APPROVED:	
L. B. FOSTER CO. PITTSBURGH, PENNSYLVANIA 15220	
FOR: MILLER CONSTRUCTION STATE OF VERMONT AGENCY OF TRANSPORTATION TOWN OF BRIDGEWATER, COUNTY OF WINDSOR VT. ROUTE 100A, BR14 PROJ. NO. BRS 0149 (4) MISC. DETAILS	
REVISED PER APPROVER'S COMMENTS	B L J 10/27 10
DATE WPO	DATE SDO339
DATE RLP	DATE LBE4
REV. NO.	1

185 PREFAB DECK PANELS

DETAIL 1 (FROM LBE1)
SUPPLEMENTAL BARS NOT SHOWN

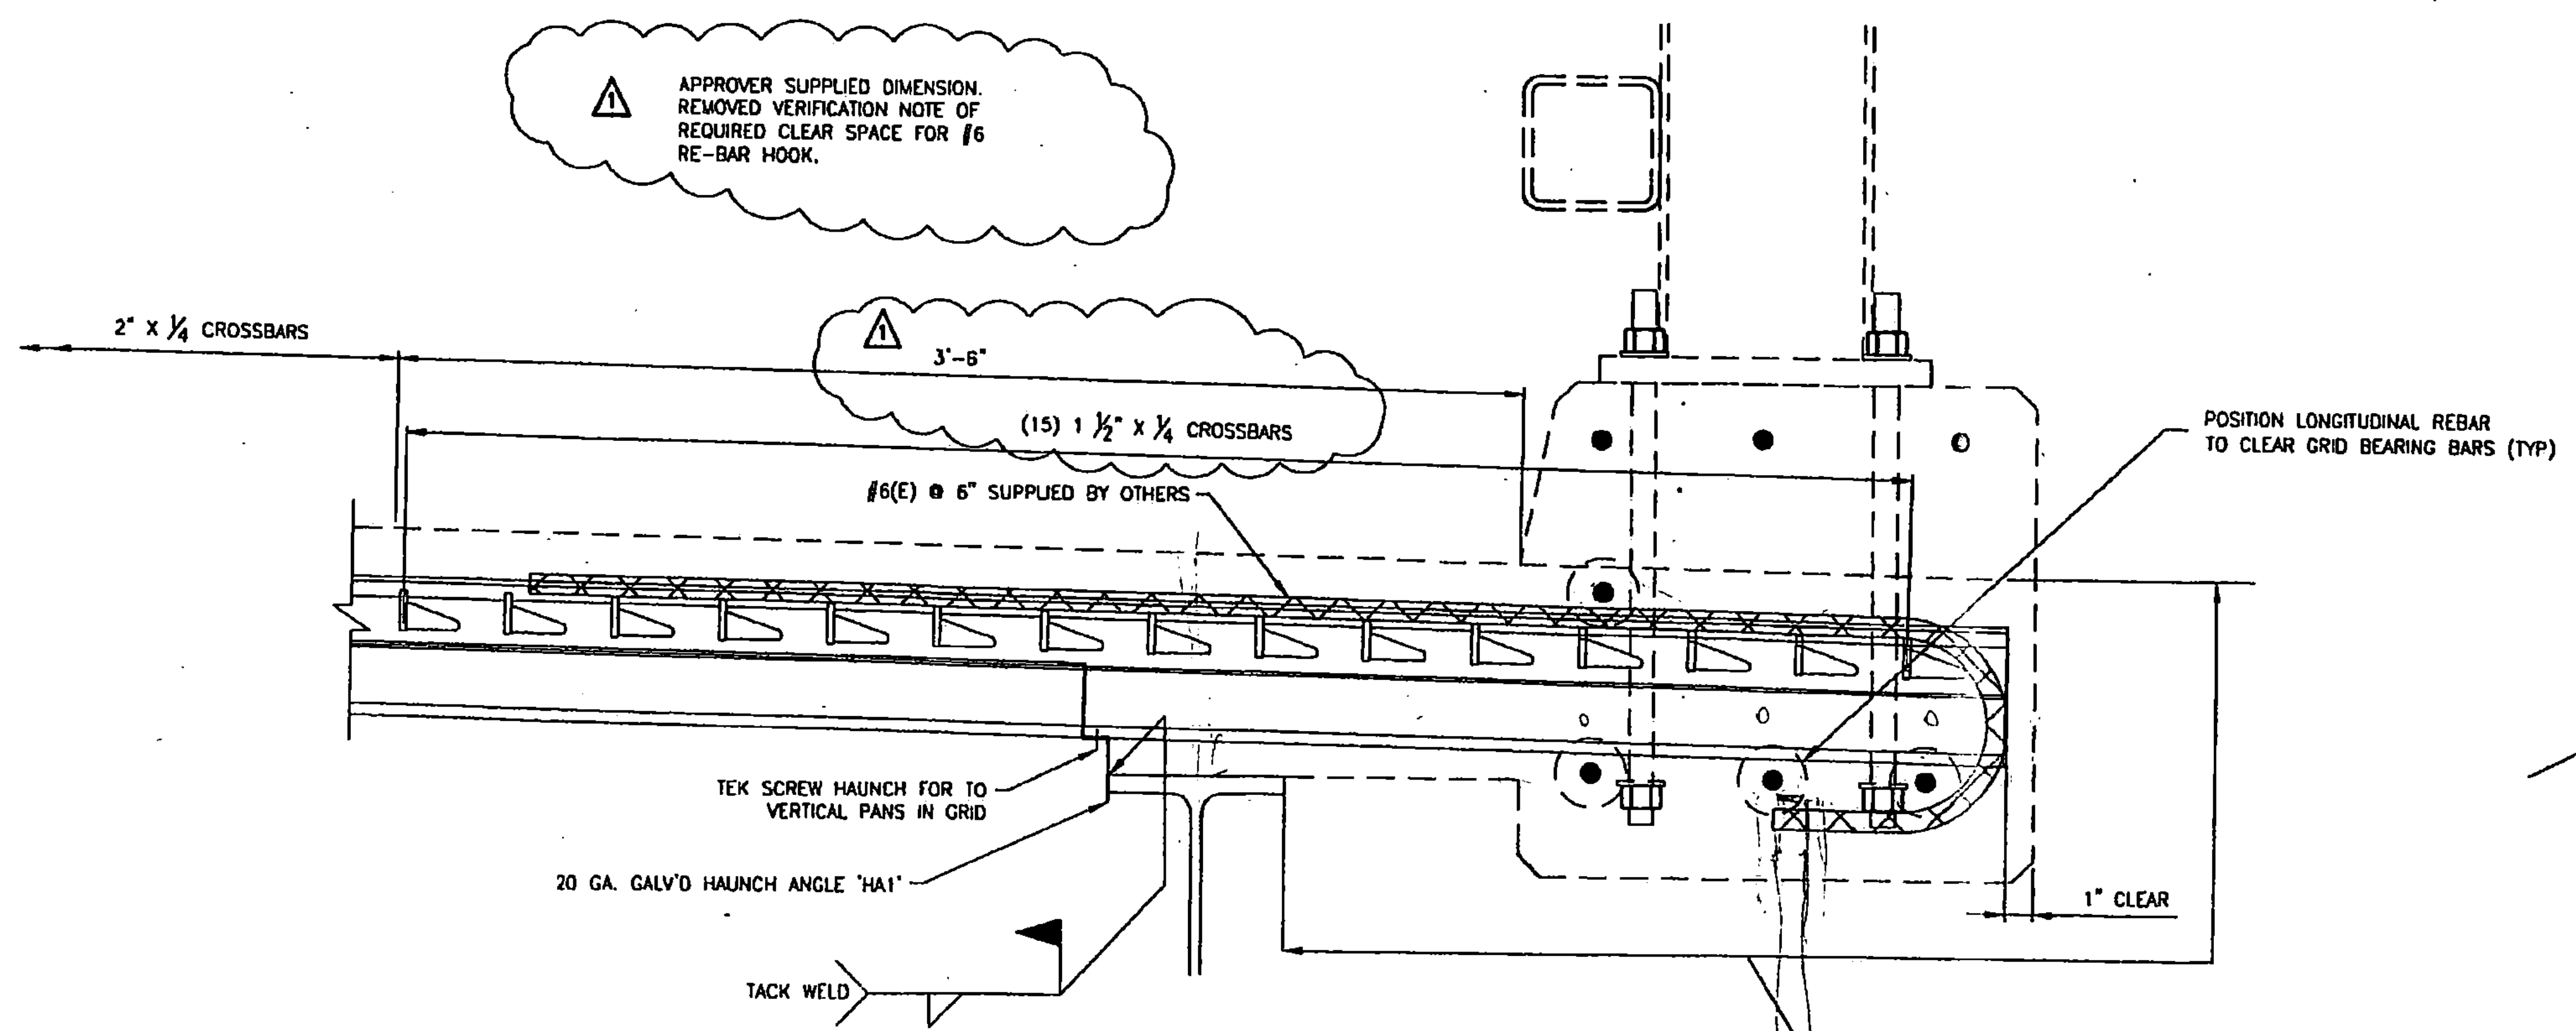
CONCRETE DECK FASCIA, CONC. FORMS BY CONTRACTOR
CONTRACTOR TO VERIFY AWARENESS AND ABILITY TO FORM CONCRETE BLOCK OUTS AT DECK PANEL CUT OUTS.

APPROVER SUPPLIED DIMENSION. REMOVED VERIFICATION NOTE OF REQUIRED CLEAR SPACE FOR #6 RE-BAR HOOK.
